**REVIEW OF THE NIOSH SITE PROFILE FOR THE
HOOKER ELECTROCHEMICAL COMPANY**

Battelle-TBD-6001, Appendix AA

**Contract No. 200-2009-28555
SCA-TR-SP2010-0034**

September 2010

Figure 1. Effect of Resuspension Factors on Dust Concentrations

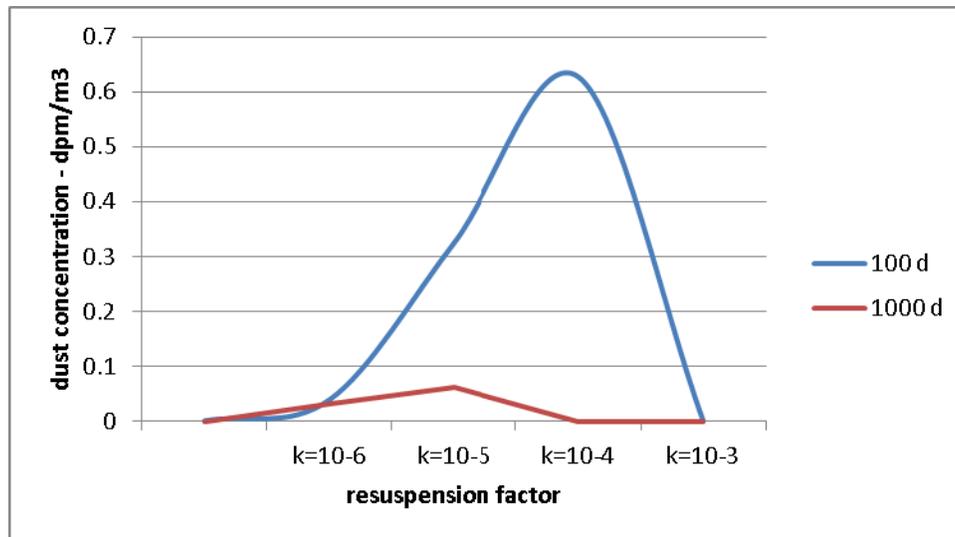
We further note that the method used here of assuming a constant surface concentration during the residual period based on deposition during the final year of the operational period combined with a resuspension factor of 1E-06/m is not one of the seven methods proposed in ORAUT-OTIB-0070 (ORAUT 2008). One method proposed in OTIB-0070 is to use the surface concentration at the end of the operation period, a resuspension factor of 1E-06/m and an assumed dust concentration decay rate of 1%/day. As pointed out by SC&A in its review of OTIB-0070, a resuspension factor of 1E-06/m is equivalent to a decay rate of 0.012%/day based on a room height of 5 m and one air change per hour (SC&A 2008). A decay rate of 1%/day is roughly equivalent to a resuspension factor of 1E-04/m. If one uses a higher resuspension factor, the initial dust concentration is higher, but the dust concentration falls much more rapidly over time. Figure 1 compares the dust concentration in the air at 100 days and 1,000 days after

cessation of operations for resuspension factors ranging from 1E-06/m to 1E-03/m. It can be seen that after 1,000 days, the dust concentration is greater for a resuspension factor of 1E-05/m than for values above and below.

However, a higher resuspension factor does not necessarily result in a higher integrated inhalation intake. When sufficient time has elapsed, a worker will experience the same integrated intake regardless of the resuspension factor. For the case modeled here, the integrated intake is the same for resuspension factors of 1E-05, 1E-04, and 1E-03/m after 10 years. A considerably longer period is required to reach the same asymptotic value for a resuspension factor of 1E-06/m.

As an alternative, NIOSH could have used an approach where the initial dust concentration was based on surface contamination at the end of operations and an appropriate resuspension factor, and assumed that this decayed exponentially to some value below the detection limit at the end of the residual period.

Finding 9: NIOSH should justify that the approach taken to calculate inhalation exposures during the residual period is bounding, and take into consideration SC&A's review of ORAUT-OTIB-0070.
